September 7, 2021

El Paso County  
Planning and Community Development Department  
2880 International Circle, Suite 110  
Colorado Springs, CO 80910

Re: Colorado Springs Utilities – Northeast Gravel Staging Area  
El Paso County Drainage Letter

**FIGURE 2**  
COLORADO SPRINGS UTILITIES  
BRIARGATE STORAGE YARD  
RELOCATION  
PRE-DEVELOPMENT DRAINAGE  
EL PASO COUNTY, COLORADO

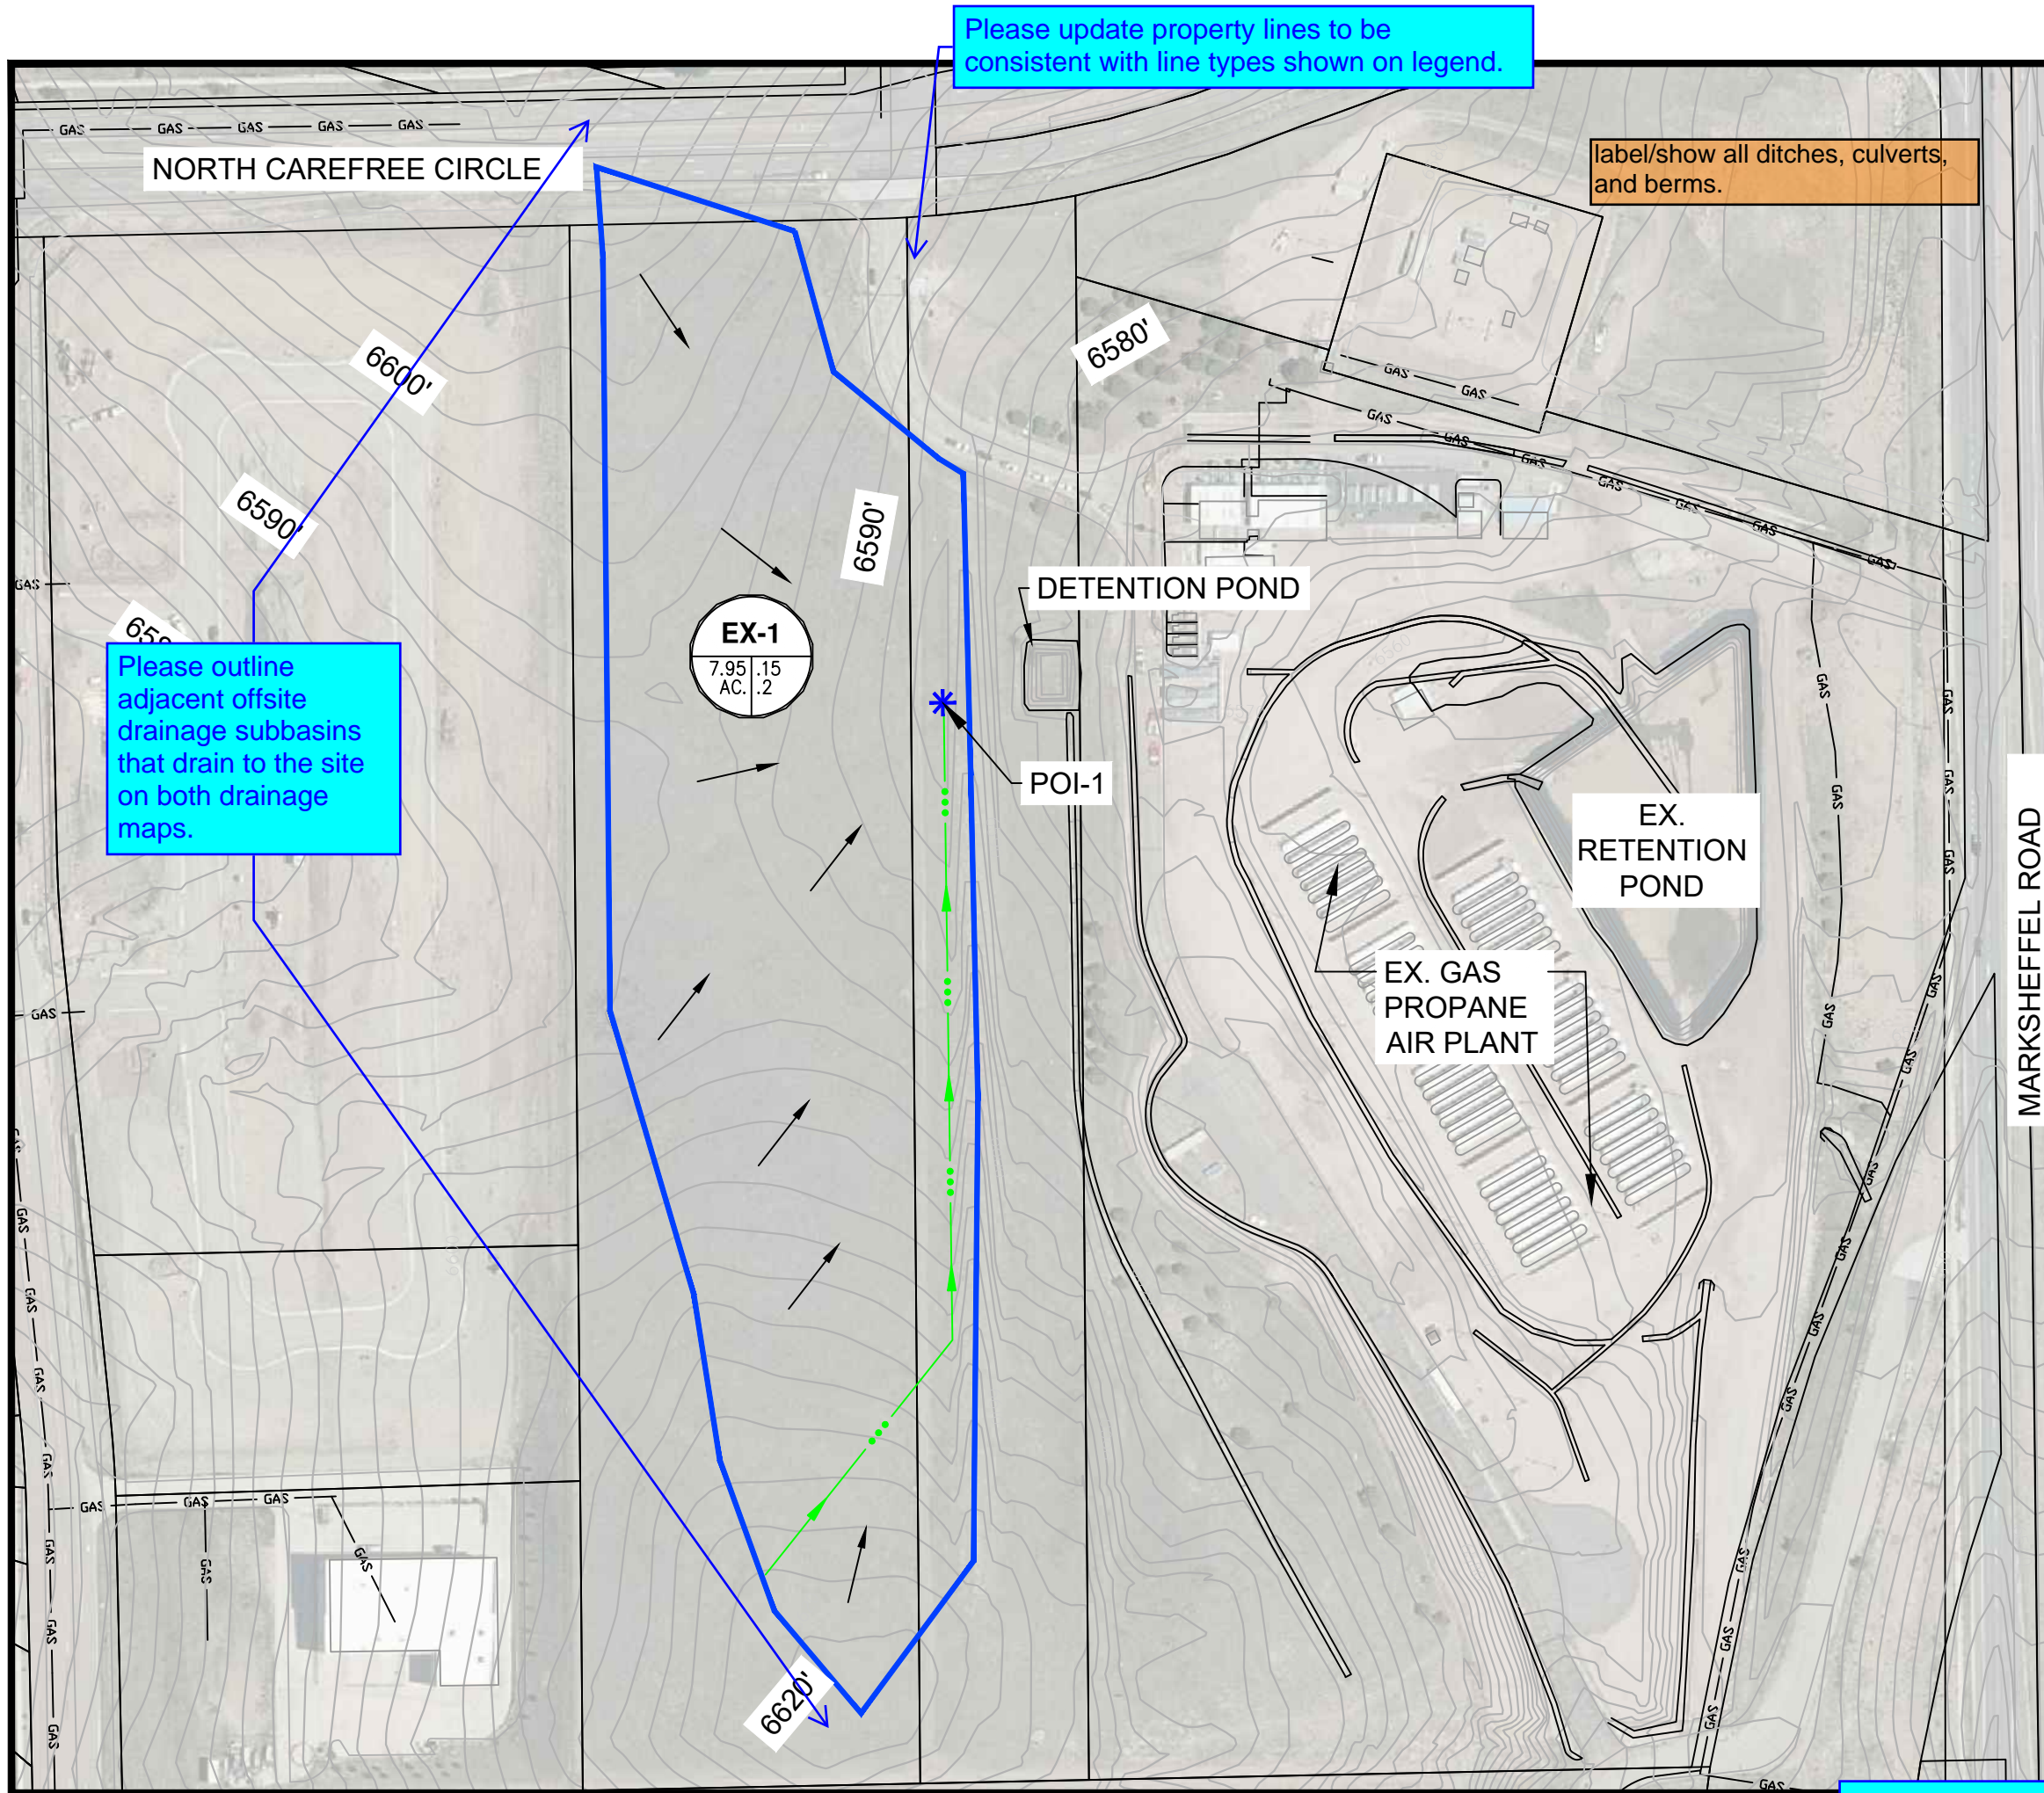
The report mentions an existing berm east of the property please show on the existing plan if applicable.

FIGURE 3

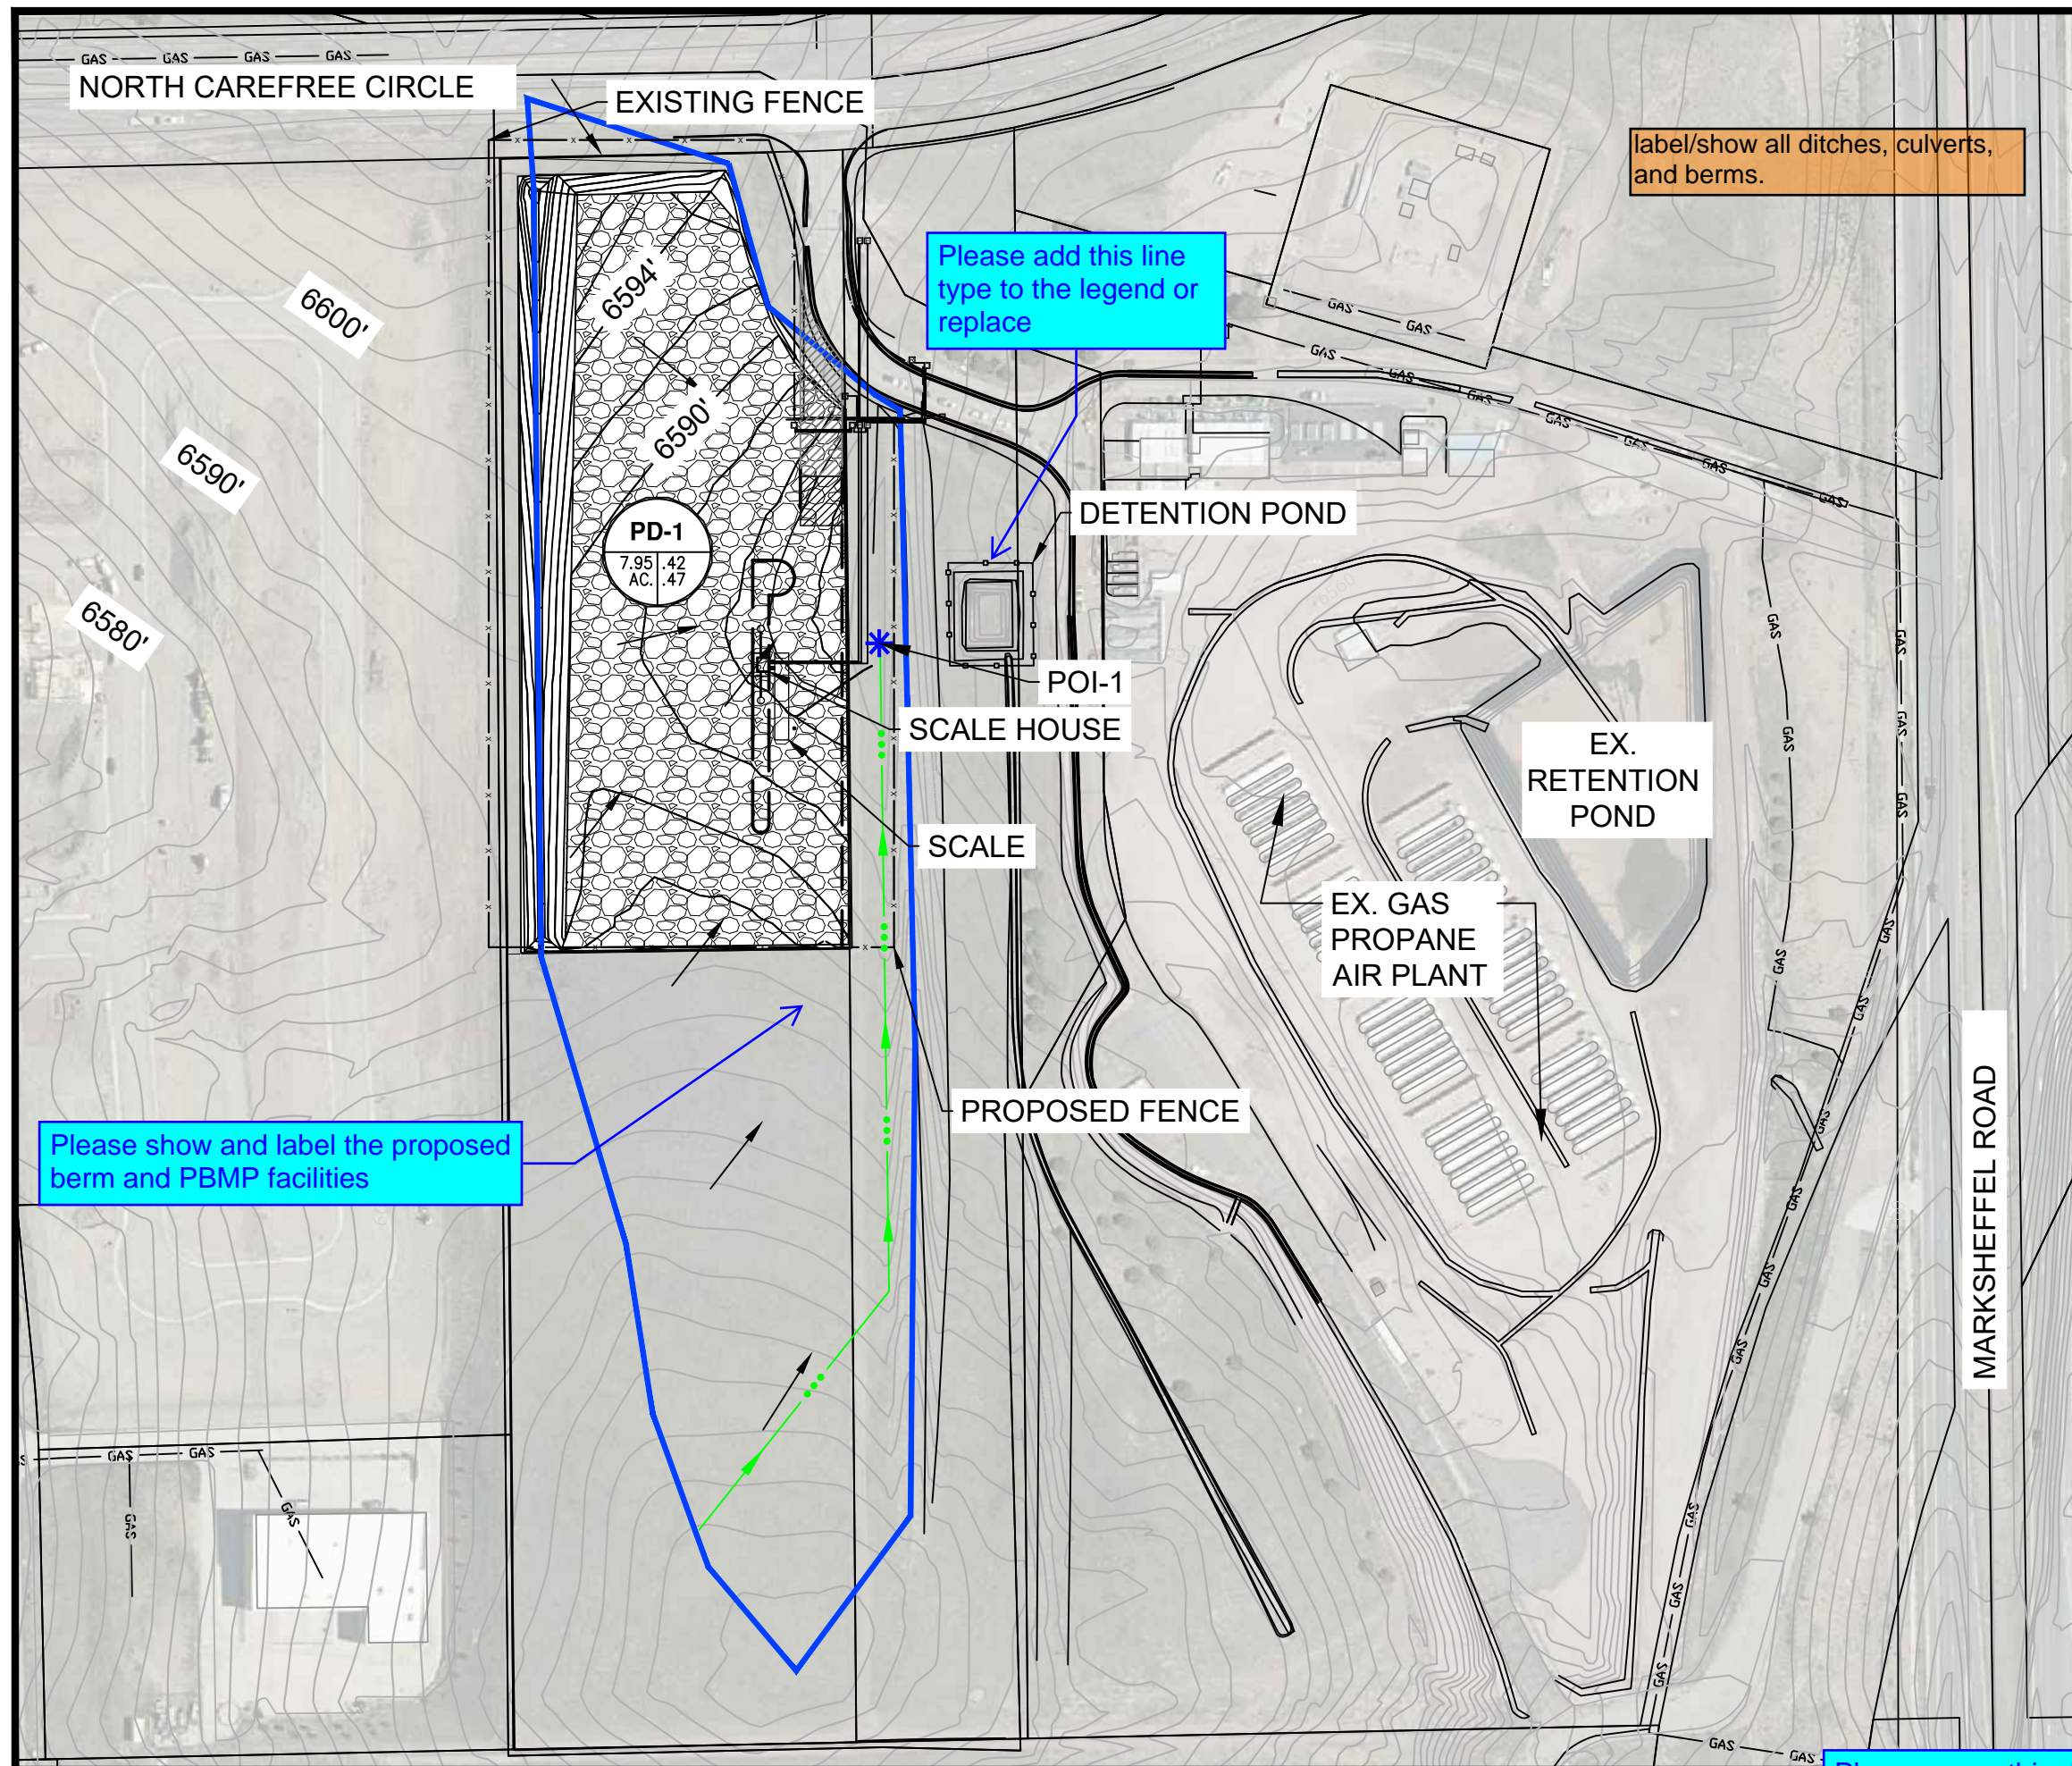
Please move this drainage map to the end of the report.

label/show all ditches, culverts,  
and berms.

Please add this line  
type to the legend or  
replace

Please show and label the proposed  
berm and PBMP facilities

Please move this drainage map to  
the end of the report.

Existing 10 year

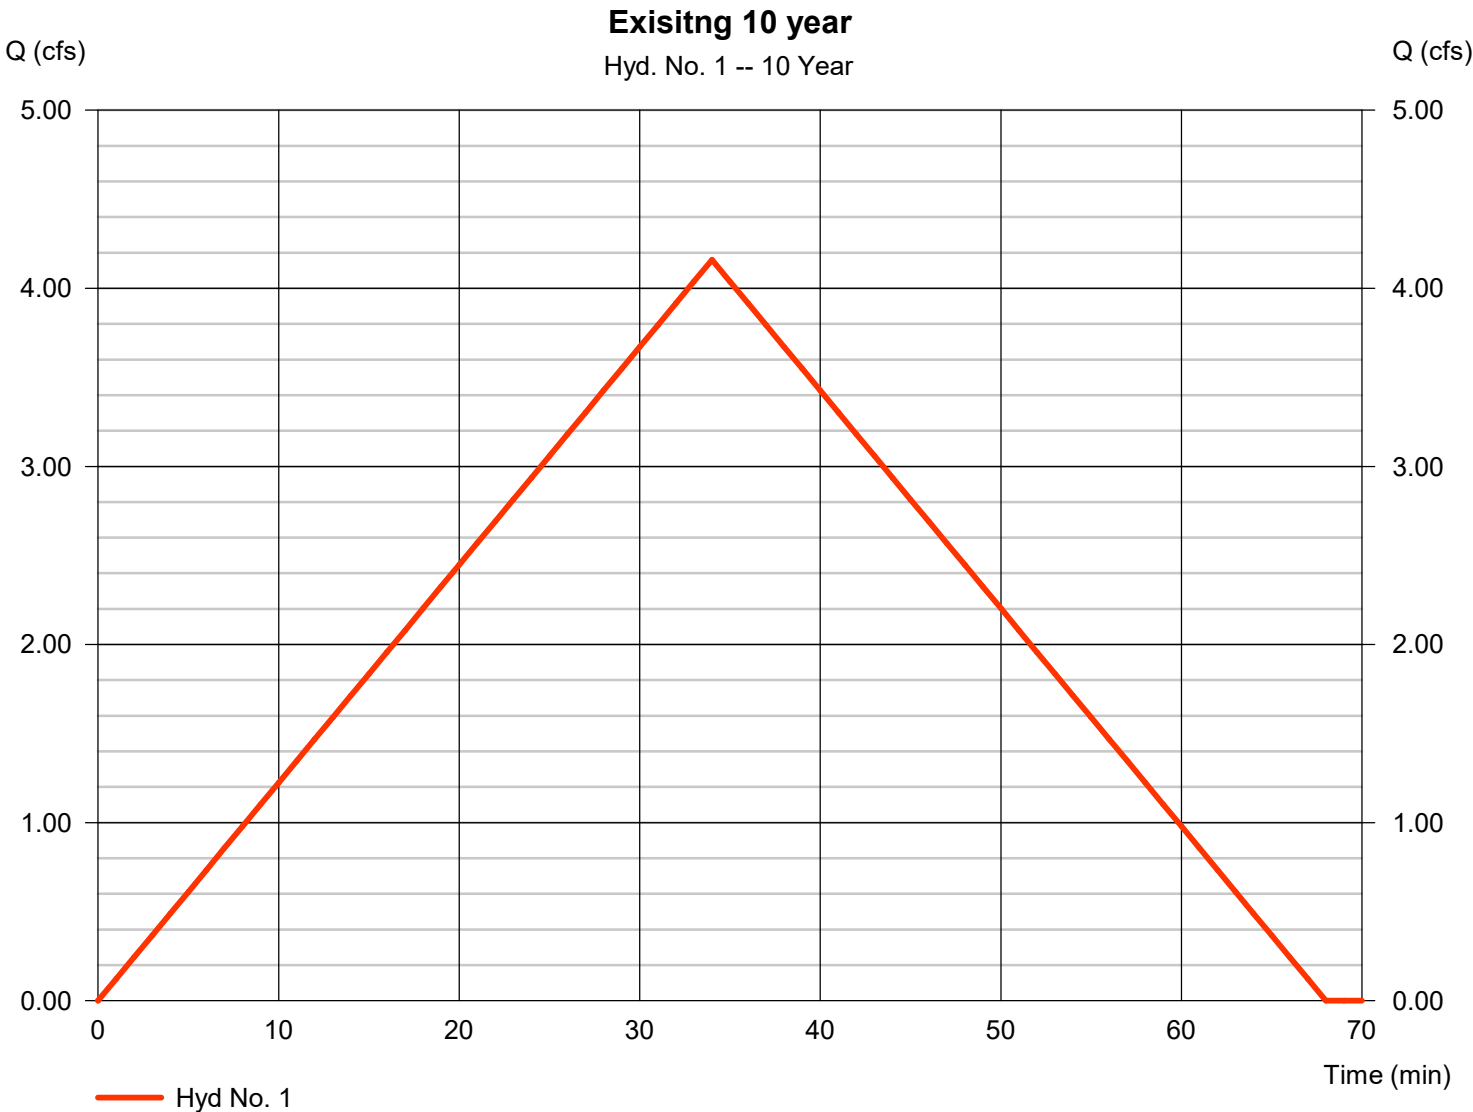
Please update point name to be consistent with report and Pre-Development Plan.

Existing 100 year

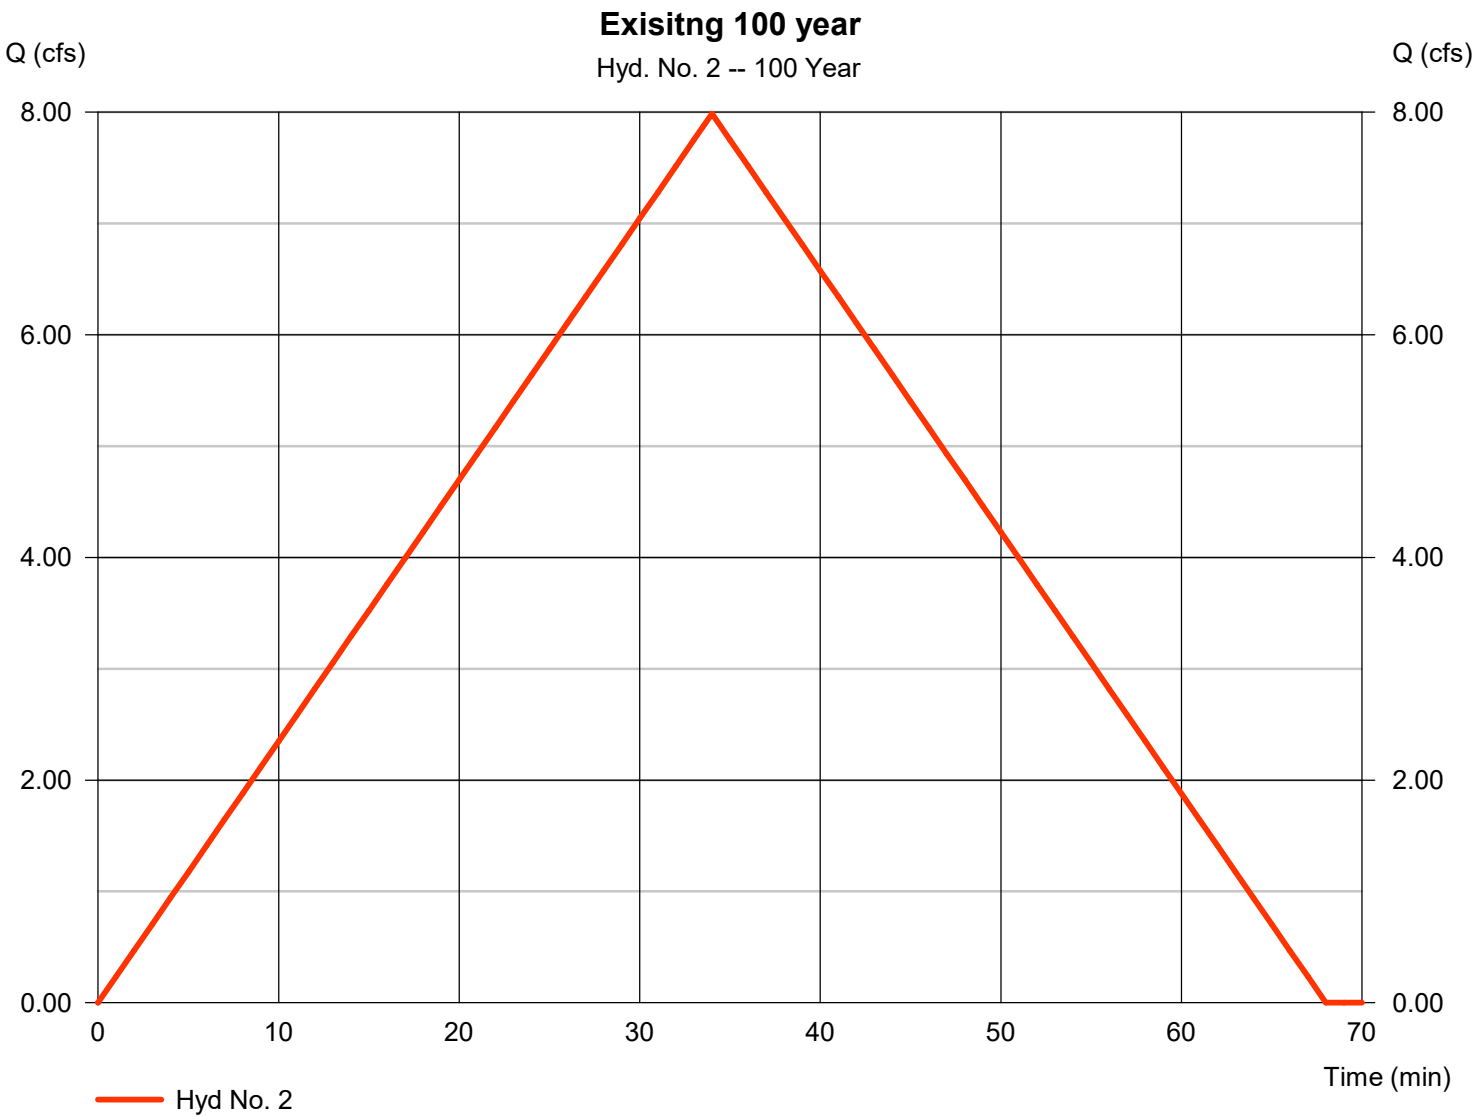
Please update point name to be consistent with report and Pre-Development Plan.
